## Proposed Equivalent Safety Finding on CS 23.1311(a)(7) and 23.1545(b)(4) at Amendment 3

### ASI Flaps Marking on PFD - Applicable to Pilatus PC-24

Figure 3. Low-Speed and High Speed Awareness for  $V_{MO}$  Airplanes

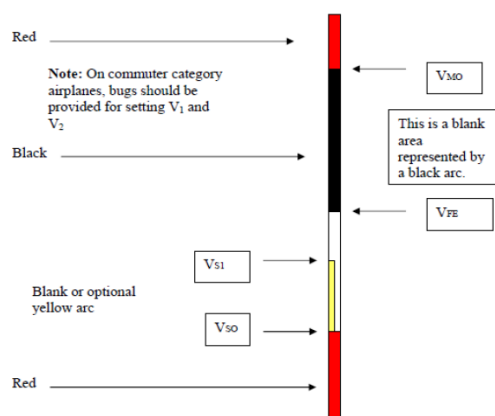
§ 17.7.2 [..] incorporate the following awareness cues [..]:

- Red band from  $V_{S0}$  to 0
- Red band from  $V_{MO}$  to top of airspeed tape
- Green arc [..] is not required [..]
- Yellow band between  $V_{S0}$  to  $V_{S1}$  is optional [..]

Figure 1 – Examples of airspeed awareness cues on the Apex system.

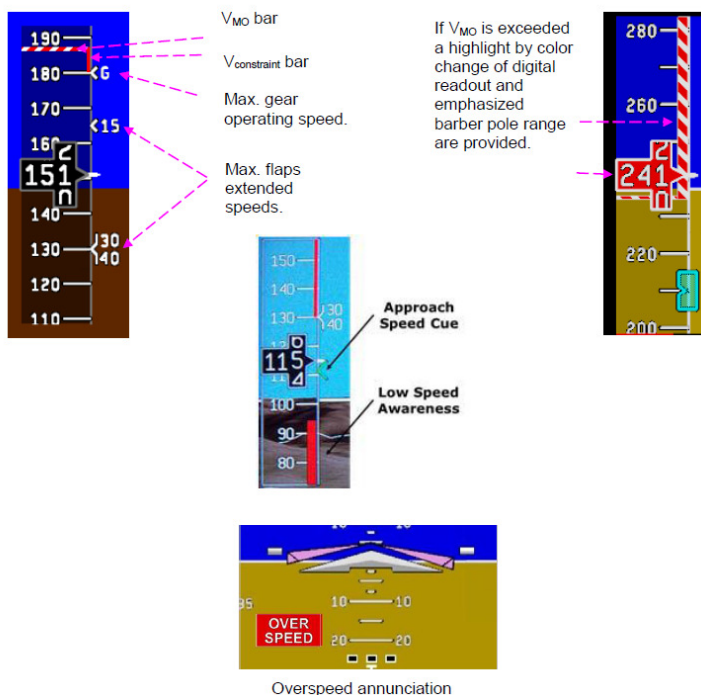
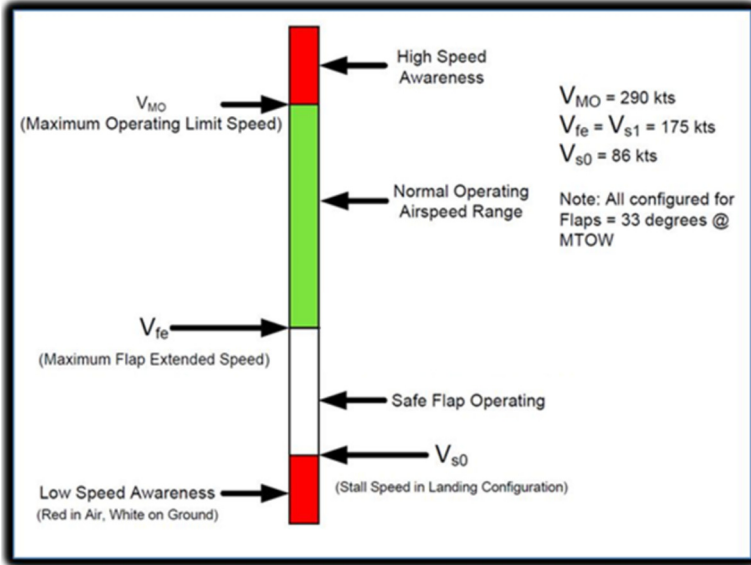
In accordance with guidance provided in FAA Advisory Circular AC 23.1311-1B, the APEX™ linear airspeed tape indicator includes airspeed awareness cues that are equivalent or superior to the cues provided by traditional round dial type indicators. These awareness cues include:

- Altitude dependent VMO/MMO airspeed limitation indication (barber pole bar).
- Aircraft configuration related airspeed constraints (red bar and speed bugs).
- Airspeed trend vector, indicating predicted airspeed with 6 seconds look ahead (white bar).
- Approach speed reference dynamic cue =  $f(\text{Mass, Accel.})$  - (green chevron  $\sim 1.3 \text{ VS}_0 / \text{S}_1$ )
- Aircraft configuration dependent low-speed awareness indication (red bar).

In addition to these awareness cues, the system also includes the following "attention getters" to alert the crew of imminent or actual alert conditions:

- "STALL" and "OVERSPEED" annunciations displayed on the ADI section of the PFD to alert the pilot of an imminent stall or speed exceedance condition.
- Color changes or emphasis of display elements (e.g. color change of digital airspeed readout).

In conclusion, Pilatus & EASA believes that the design as summarized above is providing an acceptable equivalent level of safety to what is required by CS 23.1545 (b)(4) for the following reasons:

- The design provides awareness to the crew of the airspeed range (relative to the present airspeed) within which the flaps can be safely extended beyond the 0° setting.

- The implementation of the airspeed indicator follows the guidance provided in AC 23.1311-1B and provides airspeed awareness cues that are equivalent or superior to the traditional round dial type indicator.

- The airspeed indicator markings required by the rule are written with a round-dial type indicator in mind. Applying these markings to linear tape style airspeed indicators may under some circumstances lead to conflicts with other symbols. On the Apex™ system, such a conflict would exist between the Flaps operating range marking required by 14 CFR, Part 23, § 23.1545 (b)(4) and the airspeed trend vector, both of which have the appearance of a white bar alongside the airspeed tape.
